AMENDMENTS TO THE DRAWING FIGURES

## REMARKS

Title: Universal Joint And Method Of Servicing A Staked Universal Joint  
 U.S. Serial No. 10/696,791 - Filed: October 30, 2003  
 Attorney Docket: 46107-0087  
 Reply To Office Action Dated April 4, 2005

Fig. 3A

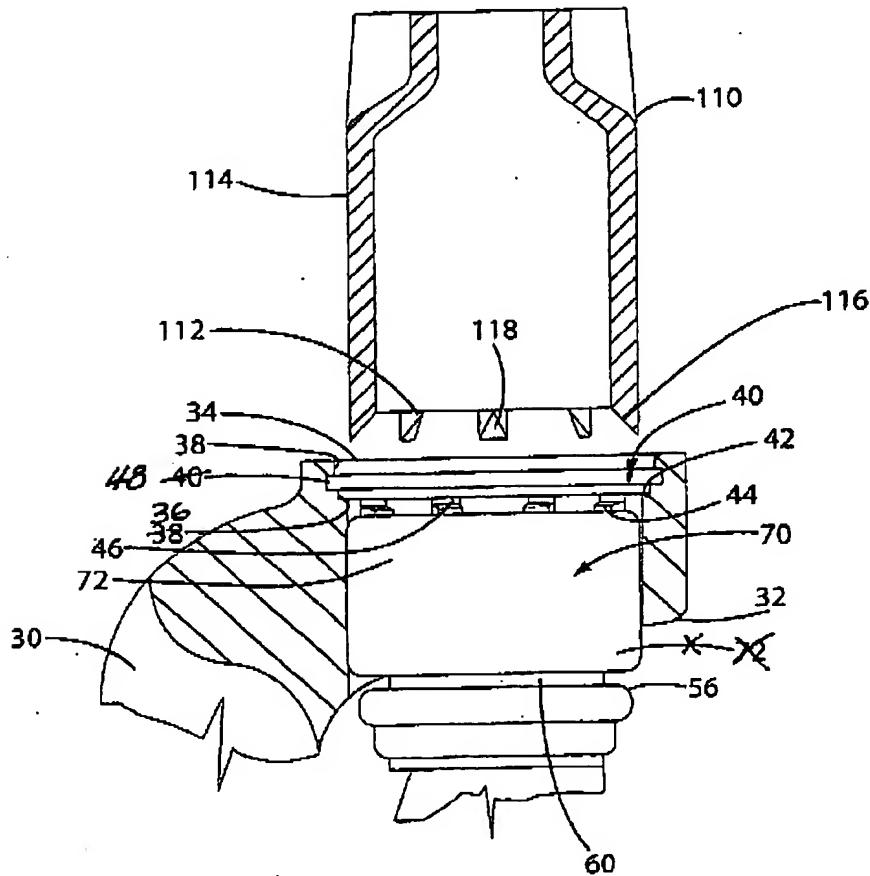
The drawings stand objected to because Figure 3A fails to include the changes made of record in the replacement drawings filed July 1, 2005. The attached Replacement Sheet, is identical to the Replacement Sheet filed July 1, 2005, except that it includes the changes marked in red on the Annotated Sheet Showing Changes, which is an appendix to this amendment.

The drawings stand objected to because Figure 3A fails to include the changes made of record in the replacement drawings filed July 1, 2005. The attached Replacement Sheet, is identical to the Replacement Sheet filed July 1, 2005, except that it includes the changes marked in red on the Annotated Sheet Showing Changes, which is an appendix to this amendment.

The Amendments to the Specification attached with this paper corrects the reference number "40" and replaces it with reference "44".
